DE-2025/82/D

SUBMISSION TO EXHIBITED DOCUMENTS

Development	Smith Street Modification 4 - Alterations and Additions (SSD-67895459-Mod-4) - Request to provide advice on the Modification Application and Report
Location	Lot 201 DP 1313965 120 Street WOLLONGONG NSW 2500

Figure 37. Flinders Street South sub-precinct - Recommended controls

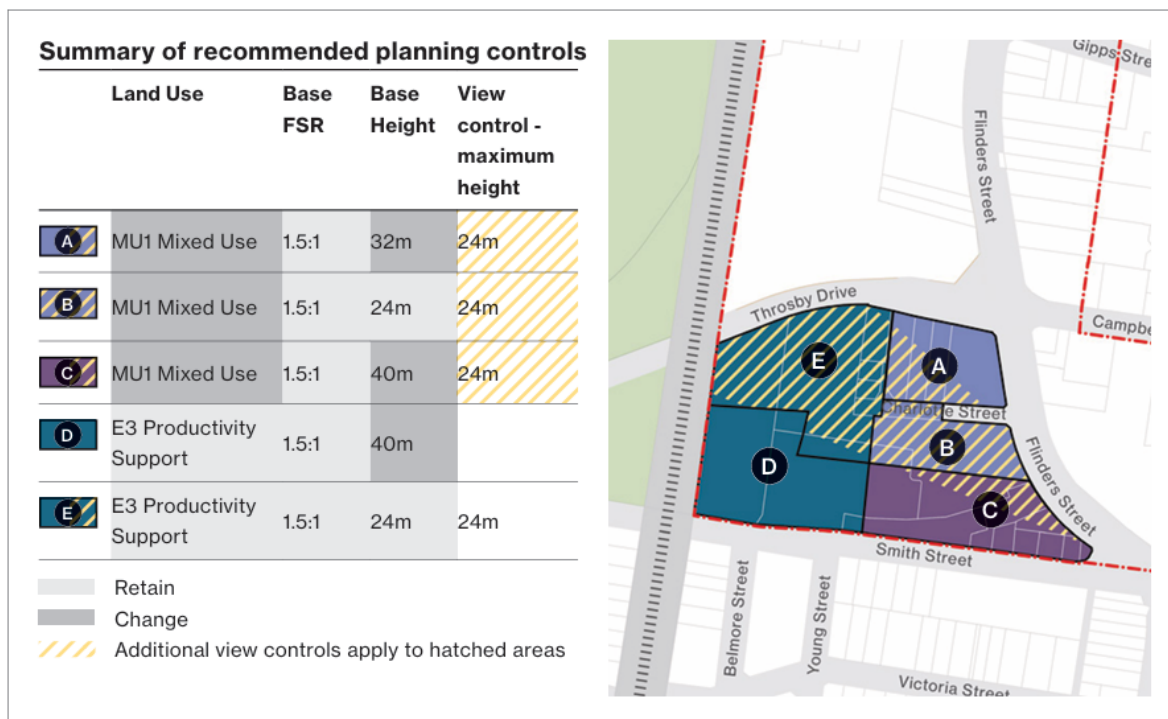
8. Council's Draft UDF was publicly exhibited 3 November-15 December 2025 and has not yet been reported back to Council.
9. The site sits within areas D and E as shown on Figure 37 of the Draft UDF. Note, the white lot boundaries in Figure 37 do not reflect current lot boundaries. Figure 7 in the Collier's report does not accurately show the site or specifically Building 2, where the extra 3 storeys are proposed. The Colliers report incorrectly states that the site is subject to a 40m height control in the UDF, however Building 2 is located within the 24m hatched area. It may be helpful for assessment if the applicant provides a plan showing the site superimposed on Draft UDF Figure 37. The applicant's Team 2 Architects plan DA-0200 Rev 3 dated 5 December 2025 shows the site's northern boundary is a continuation of Charlotte Street.

10. Views to Mount Keira from various locations within the precinct, including the Keira/Smith Street intersection, remain important and highly valued and are reflected in the Draft UDF.
11. The proposed additional three storeys at the rear of the subject site is inconsistent with the Draft UDF – 4.5 Sub precinct (Flinders Street South) as:
 - The additional building height is located within the proposed hatched view corridor
 - Does not comply with the view corridor height limit of 24m, and
 - Does not locate additional height within the identified increased height corridor along Smith Street
12. Consequently, justification for these inconsistencies is to be submitted to the Department for assessment outlining why such a departure from the Draft UDF should be supported.
